MODIFICATION REQUEST:

61-79 Hall Street, Bondi Beach

MP09_0081 MOD 4 – Internal and external design changes and amendment to a condition relating to public art

Director-General's
Environmental Assessment Report
Section 75W of the
Environmental Planning and Assessment Act 1979

Figure 3: Proposed Ground Level Plan

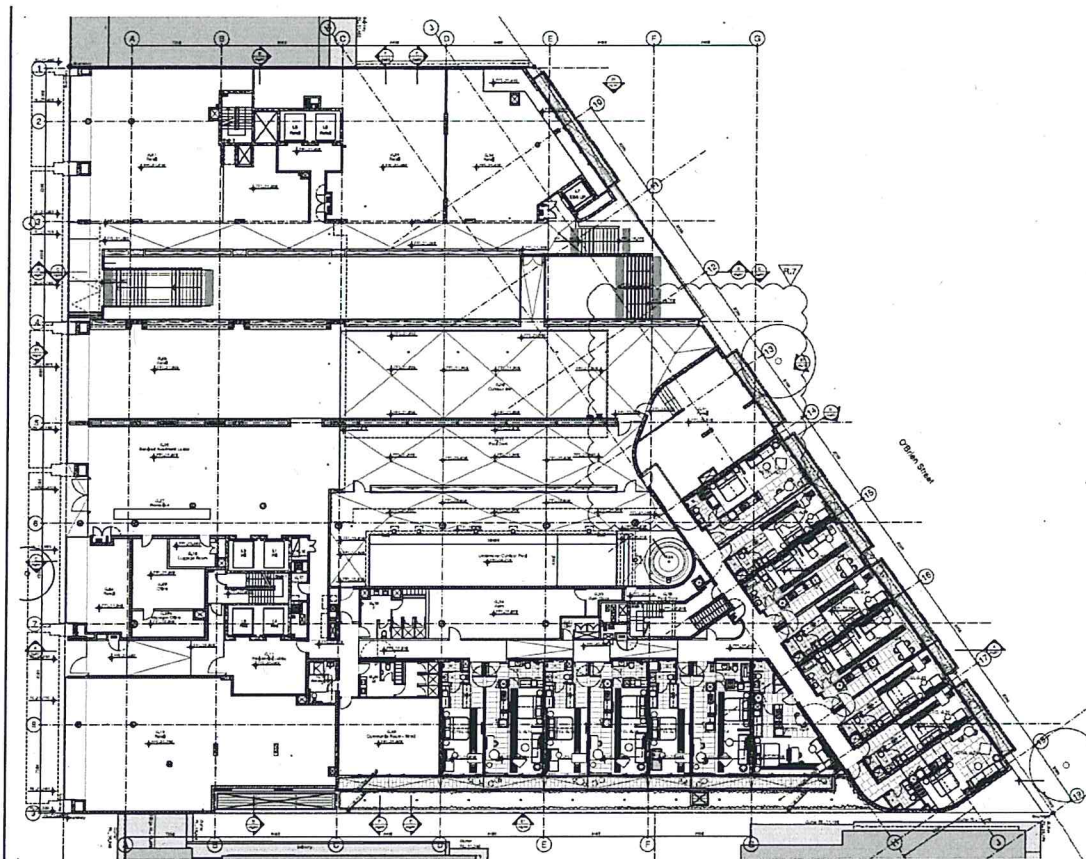
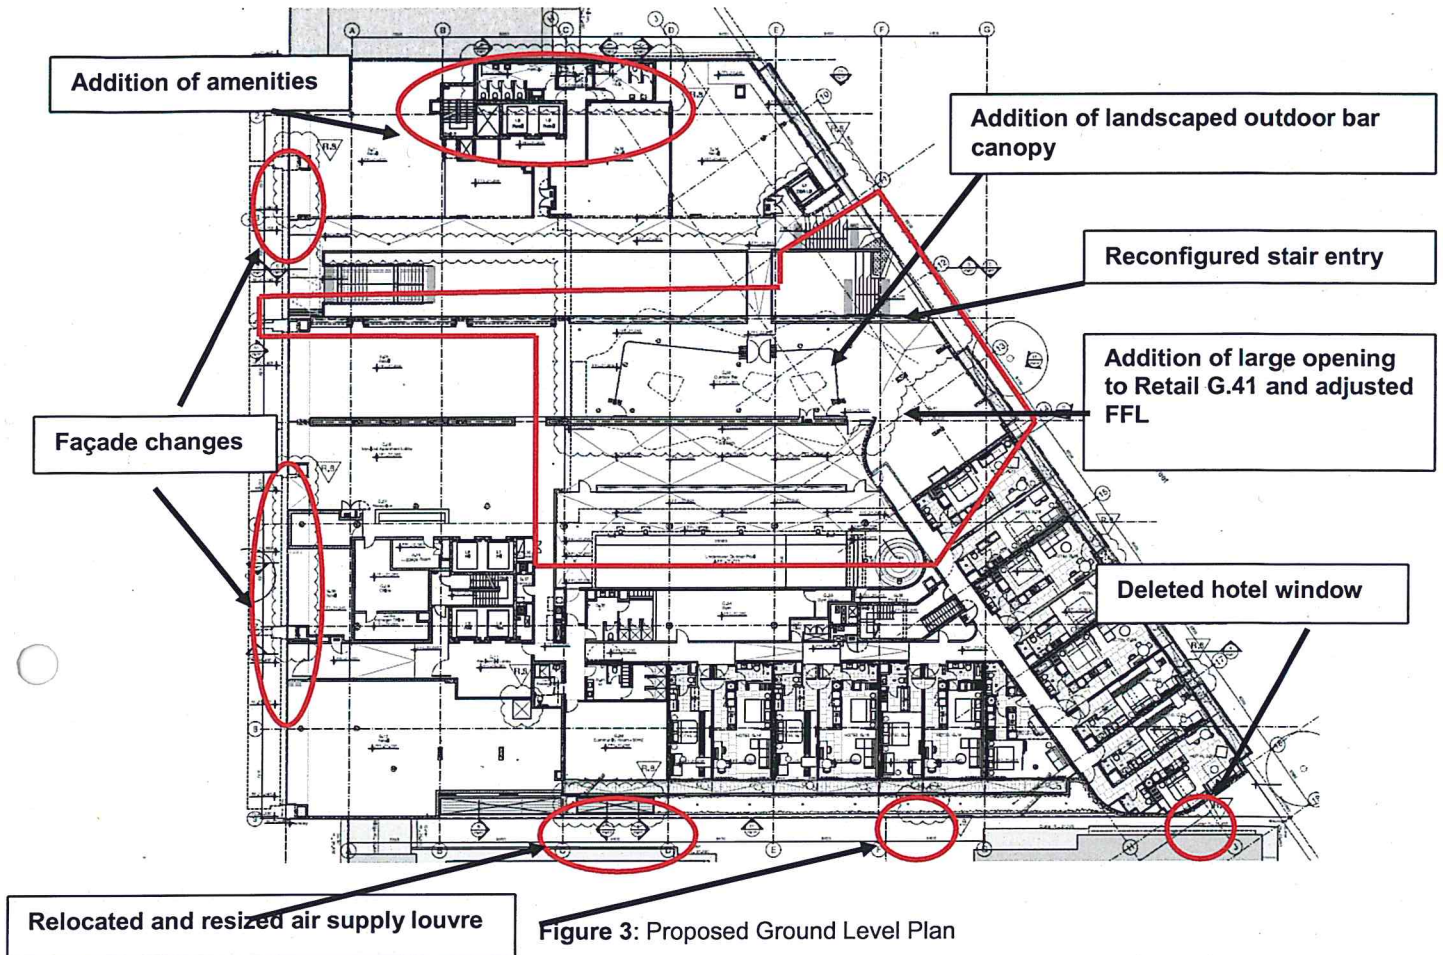
- Deletion of a side window to hotel room G.20;
- Entry stair to retail area G.41 is to be eliminated and replaced with a large opening. The finished floor level (FFL) is adjusted to the same level as the adjoining space;
- Design changes to the outdoor bar canopy to include a curved irregular landscape roof. The material of the canopy is changed from glass to masonry to improve the acoustic performance of the canopy;
- Additional amenities provided behind Lift 5 and 6;
- Minor changes to Hall Street shopfronts and retail areas G.01 and G.08; and
- Relocation and re-sizing of the small air supply louvre to a larger form situated within the south-east setback area.

Modifications are proposed to the outdoor canopy over the G.30 outdoor bar on ground level. The form of the canopy has been reconfigured from a rectangle to a curved irregular shape and the material has been changed from glass to concrete. The original restaurant noise emission assessment by Acoustic Logic dated May 2011, specifies a glass canopy and sliding door arrangement to control noise emissions to the residential and hotel areas of the development.

The department has considered the acoustic advice offered by the proponent's consultant and deems that the modification to the outdoor bar canopy is acceptable as it will improve its acoustic performance, and will provide better shading and thermal comfort to patrons underneath the canopy.

Figure 4: Proposed Level 7 Plan

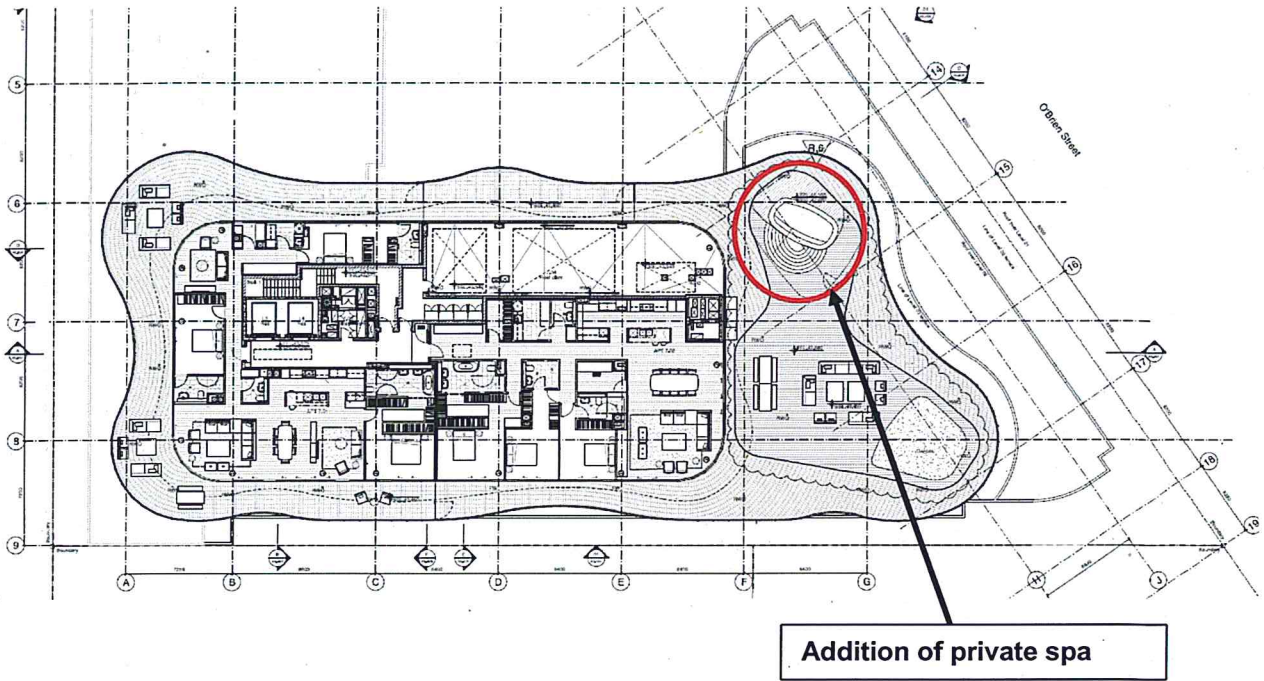
Waverley Council raised no objection to the proposed modifications but requested the department give due consideration to the visual bulk and view impacts created by the new spa on Level 7.

A spa of approximately 2.8m x 4.8m dimensions is proposed to be located on the northern corner of the terrace to Level 7 overlooking O'Brien Street (see **Figure 4**). The spa will be 1610mm above the FFL of the Level 7 terrace and will extend 350mm above the slightly coloured glass balustrade (see **Figure 5**). The setback of the spa deck from the balustrade varies in length due to the curvature of the terrace, from 1.1m at its shortest distance to 2.1m at its longest. **Figure 6** depicts the setback of the mounted spa deck from the balustrade that may be perceived from O'Brien Street.

Council raised concerns that the spa structure may be seen from the street below. The department has considered council's comments and notes that the proposed spa will be adequately obscured from public view due to its setback from the balustrade and the view angle of the spa from O'Brien Street. In addition, the colouration of the glazed balustrade will improve concealing the spa deck from public view. In this regard, the department believes that there would be no detrimental visual impact arising from the proposed spa.

Figure 5: Detailed section of proposed spa on Level 7

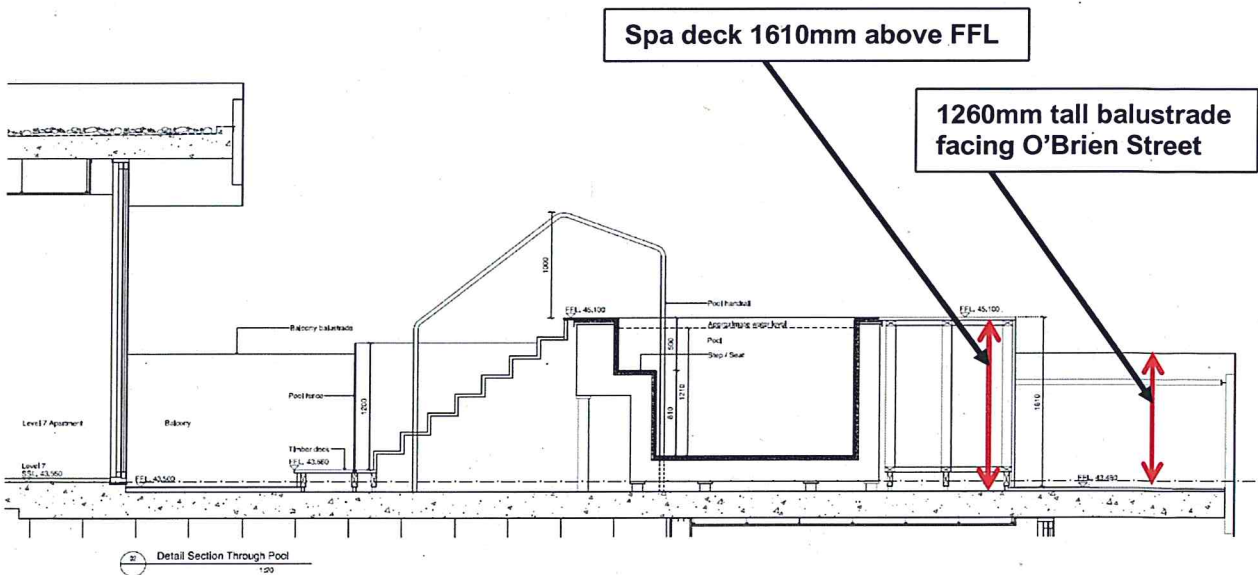
- Modified landscape plan for roof terrace Apartment 7.02, with the addition of a timber deck that is 90mm above the FFL, a garden and an above-ground spa. The spa sits 1610mm above the timber deck and rises 350mm above the roof terrace balustrade (see **Figure 5**).
